Work Order ID 136946

Item Name: Lower Deflector

From: Pablo Bravo
Sent: July-31-15 12:56 PM
To: Jean Francois Sauve
Cc: Jean-Luc Menard; Mario Poulin; Jason Gardiner; Alex Quan
Subject: RE: 135 CCK
Attachments: 647.7611.jpg; 647.7612.jpg

647.7611

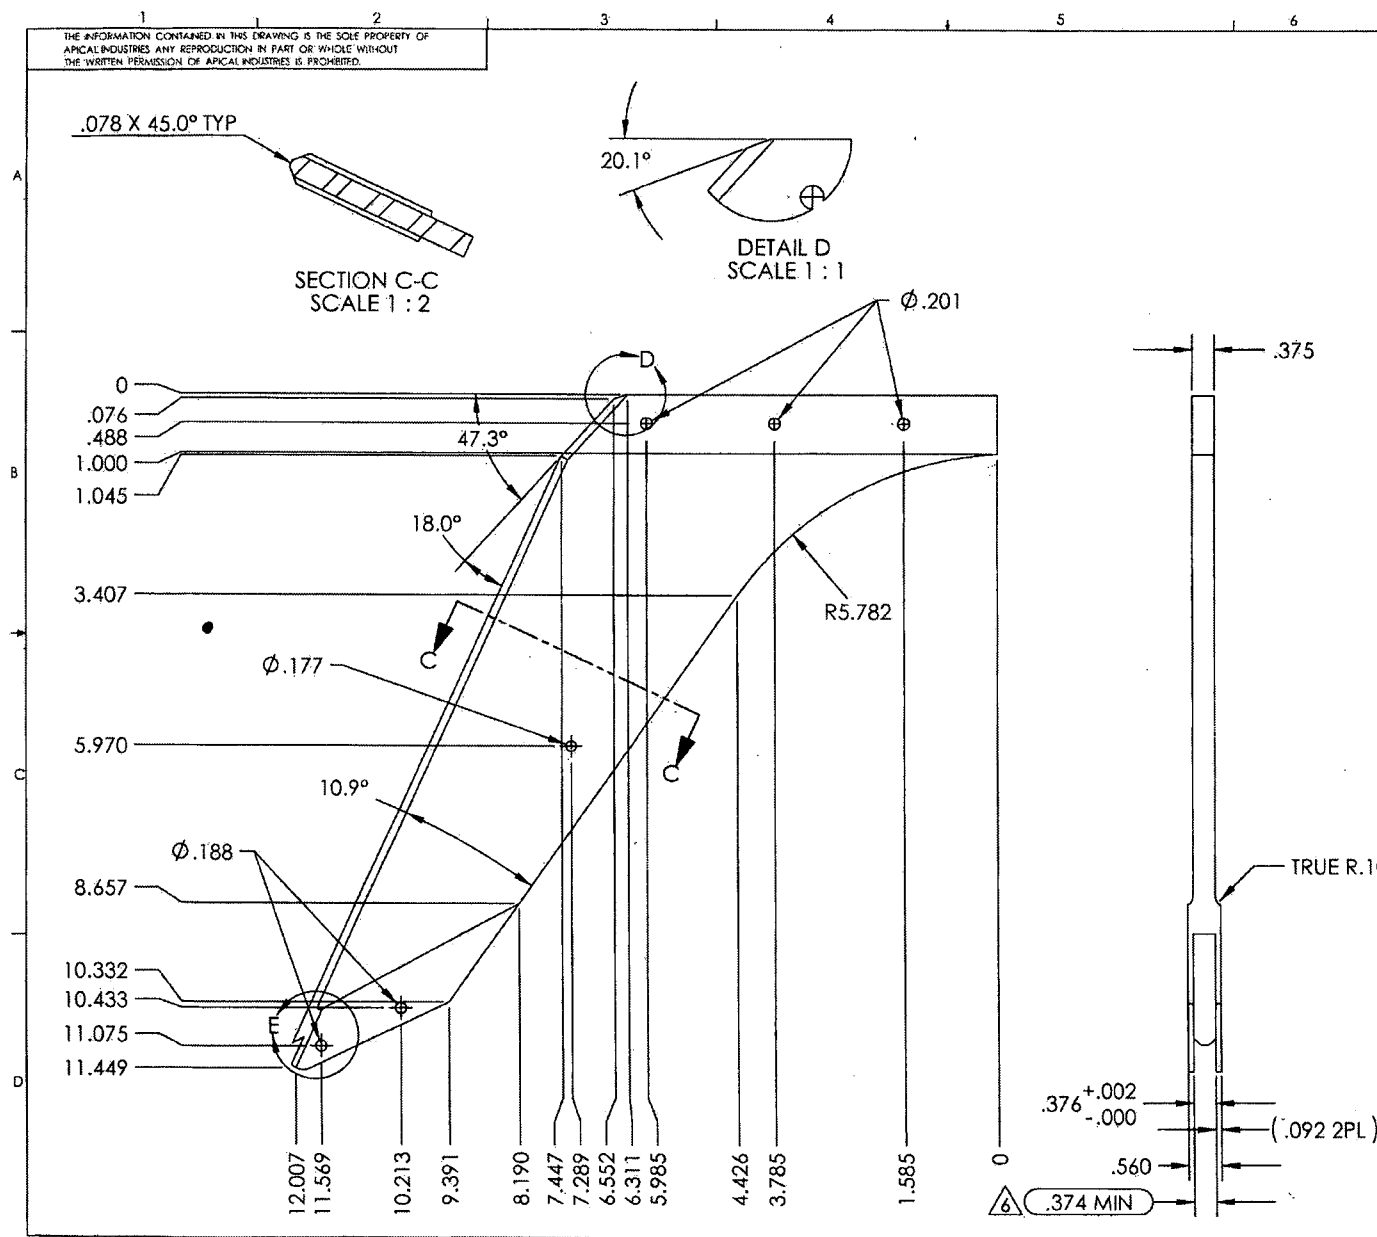
Concerning 647.7811 / .7812 Deflectors. The Chamfer called on the dwg. doesn't reflect the Cad model. Both are at 1/8" x 45 deg. on the Cad model.

Please let me know if I go with the Cad. model or the dwg.

Go with the dimension on the models. It looks like this has to do with the way Solidworks interprets the feature on the drawing. We'll have to make a correction to the drawing file.

Jason/Alex, can you guys add this to the list of drawing changes that need to be implemented?
